## APPLICATION FOR CERTIFICATE OF APPROPRIATENESS AND ZONING RELIEF HISTORIC CONSERVATION BOARD PUBLIC HEARING STAFF REPORT

APPLICATION #: ZH20180080  
APPLICANT: FRCH Design Worldwide  
OWNER: Cincy Downtown Lodging Associates LLC  
ADDRESS: **299 E. 6<sup>th</sup> Street**  
PARCELS: 078-0002-0023  
ZONING: DD-A  
OVERLAYS: Duttenhofer Building Historic Landmark  
COMMUNITY: Downtown  
REPORT DATE: May 16, 2018  
HEARING DATE: June 6, 2018  
STAFF REVIEW: Douglas Owen, Zoning Plan Examiner

1. Section 1411-39 – **Dimensional Variance** of 4 feet for a projecting sign of 12 feet in height, in excess of the 8-foot limit per plans submitted by FRCH Design Worldwide dated March 23, 2018 with the following condition:
  - i. A Revocable Street Privilege must be obtained from DOTE prior to erection of the signs.

**A. APPROVE** a Certificate of Appropriateness for 299 E. 6<sup>th</sup> Street per plans submitted by FRCH Design Worldwide dated March 23, 2018 including any revisions submitted for permit subject to staff review and approval with the following condition:

**hc5.01**

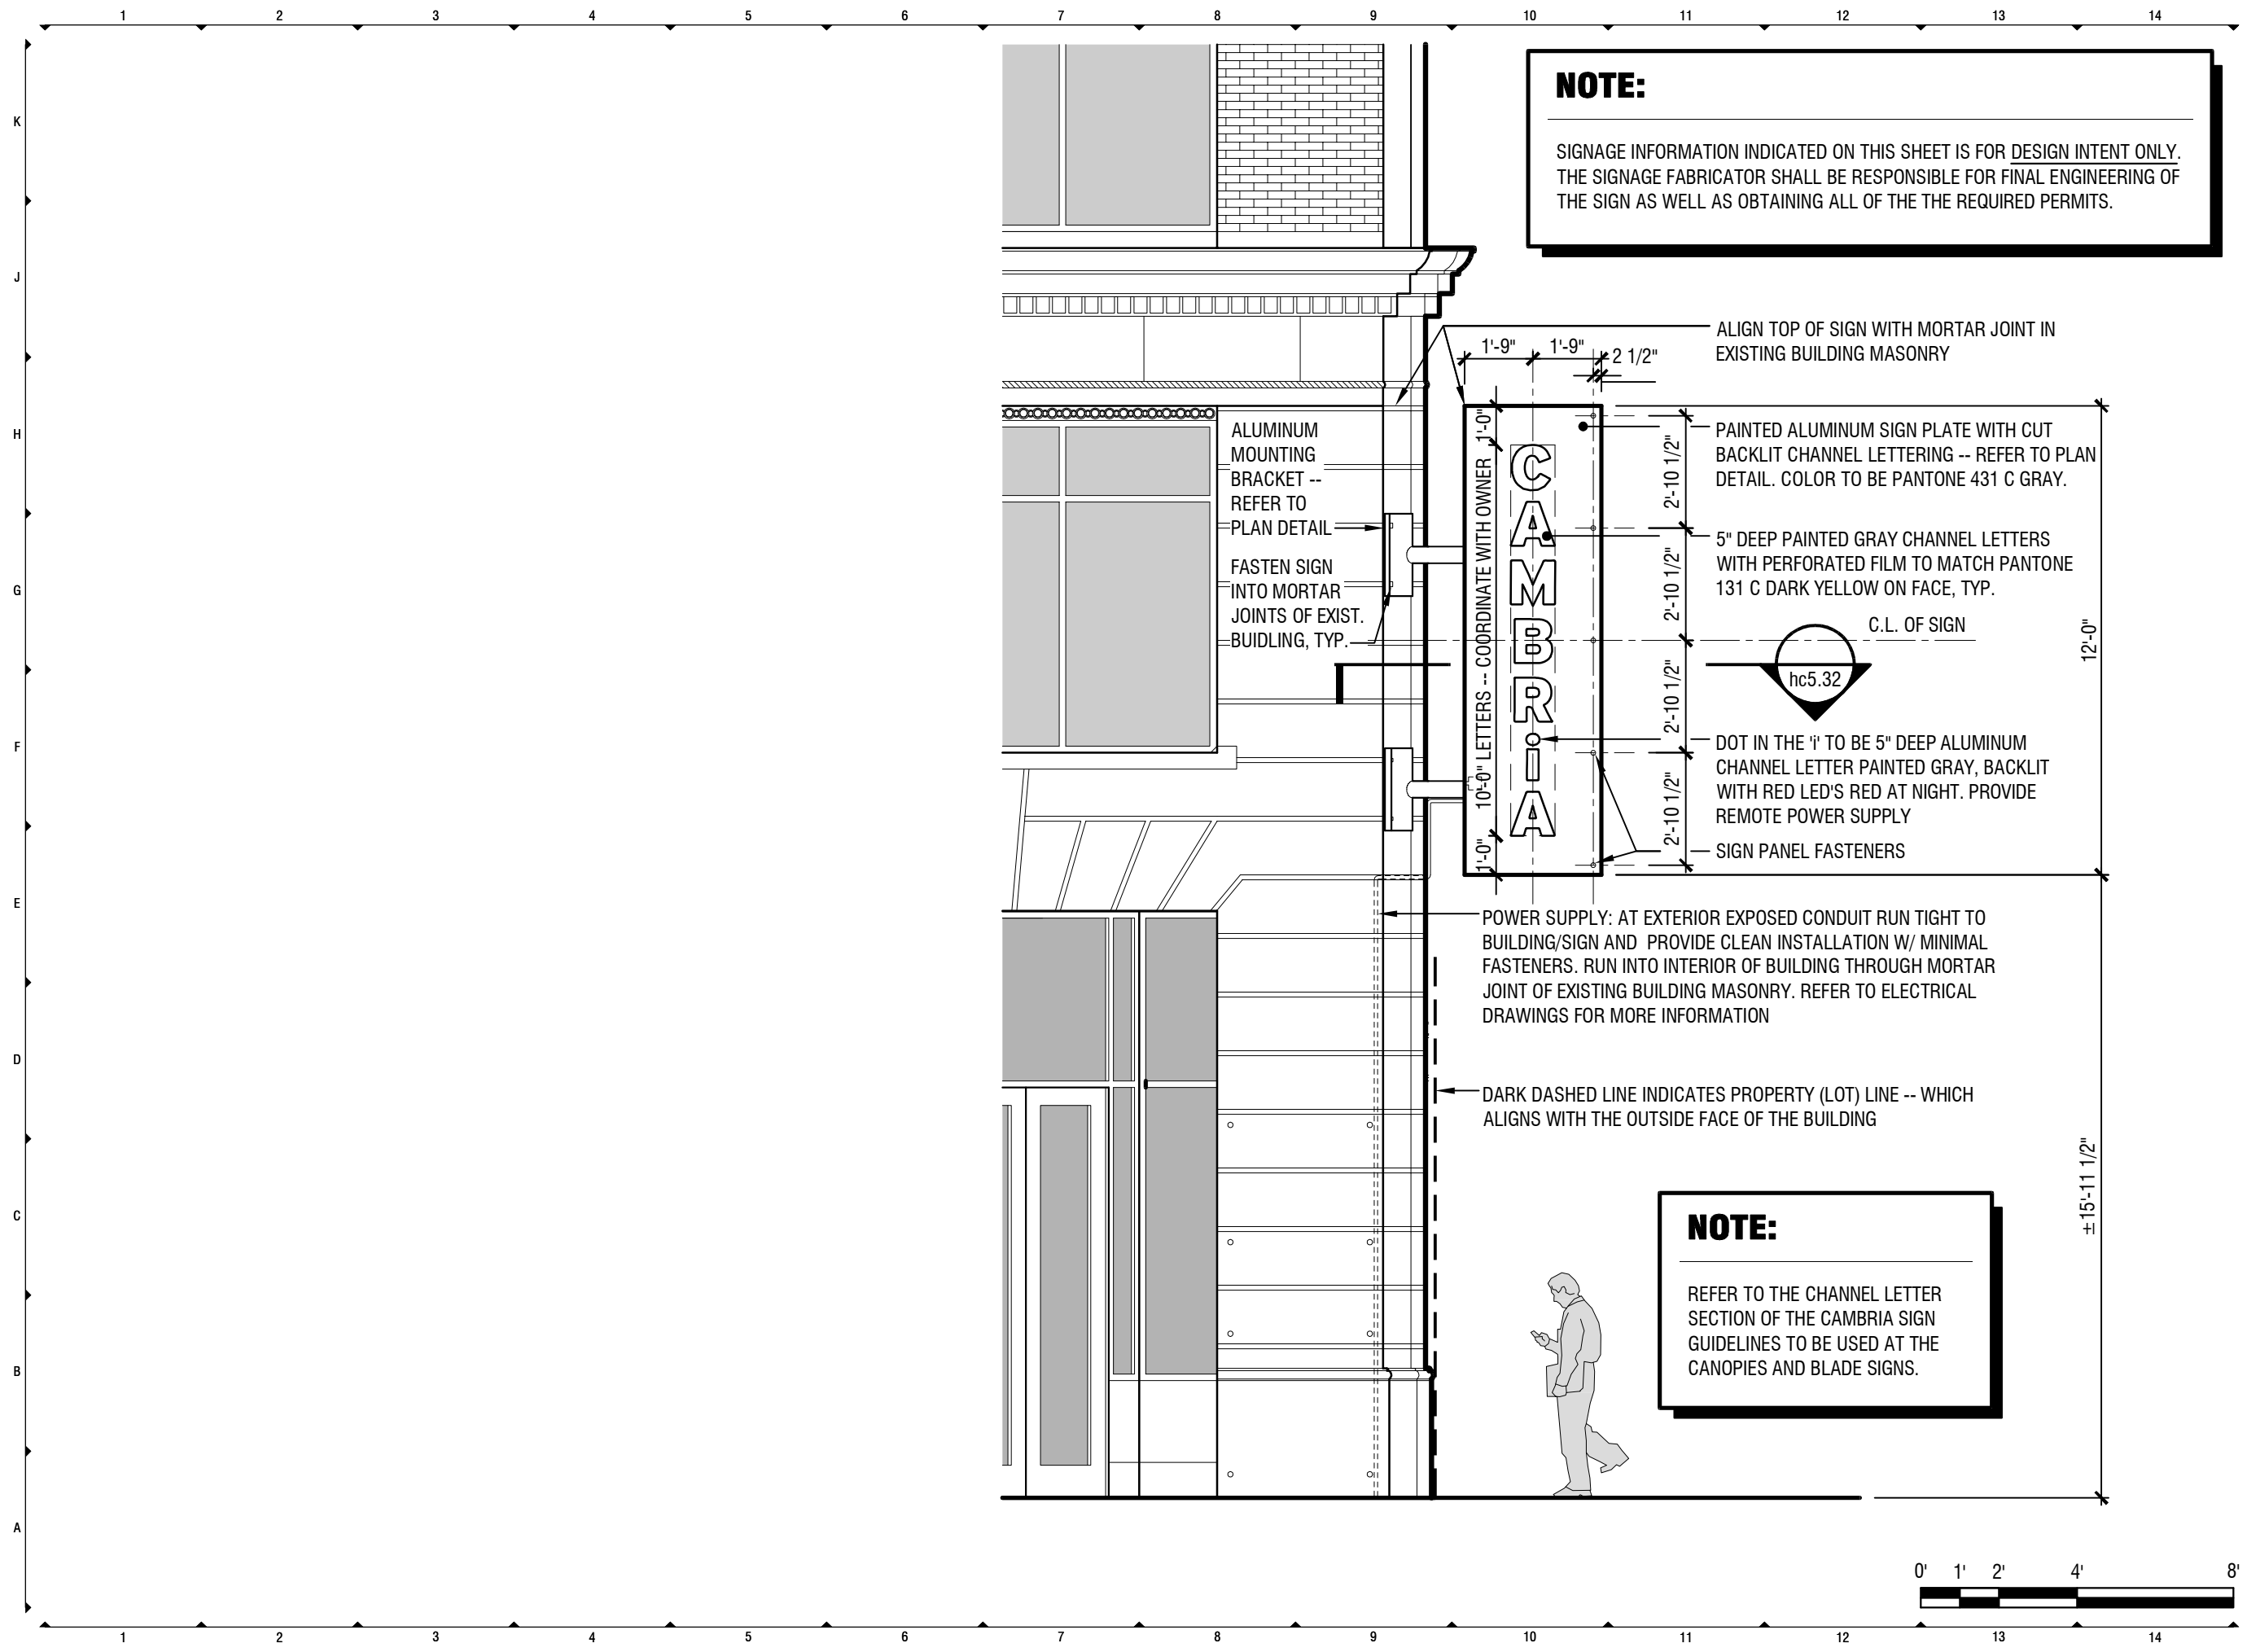
The applicant is proposing to modify the property with a new projecting sign at the northeast corner of the building. At 3.5' wide by 12' high, the sign exceeds the maximum allowable height of 8' per the Zoning Code. Previously approved permits include work on the storefronts to restore the original height and configurations of the storefront windows.

The applicant requires Zoning Relief for the proposed signage, which exceeds the maximum height for projecting signs in the DD District by four feet.

While the proposed projecting signs exceed the allowable height in the district, the overall sign is appropriate to the scale of the building. Furthermore, there is very little signage on the building as a whole. Aside from small signage on the proposed canopies, the projecting sign is the only other signage on the building.

The denial of the requested variances would not deprive the property of all economically viable uses; however, the sign does help to promote the business. Without effective signage, the business is unlikely to be easily identified and frequented by passersby.
